Photo Report

Verdugo Park

Finding: The Verdugo Park, located 1621 Canada Boulevard in Glendale California, was inspected by Disability Access Consultants, Inc., on June 5, 2007. Facilities include the Verdugo Park Skate Park Operations Office, Caretaker's House, Food Service Building, Maintenance Building, North and South restrooms, Stengel Field, and the Stengel Field Stadium.

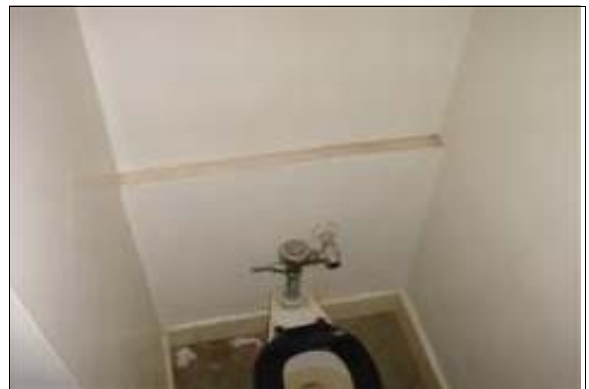
Finding: The urinal in the restroom is floor mounted and does not provide a tapered, elongated rim. The flush control valve on the urinal is greater than 44 inches above the finished floor.

Full Rec: Replace the urinal designated to be accessible in the restroom with a wall-mounted or stall-type tapered, elongated rim unit complying with ADAAG 4.18.2. The height of the rim surface of the urinal designated to be accessible shall not exceed 17 inches above the finished floor and the flush control valve shall not exceed a height of 44 inches above the finished floor.
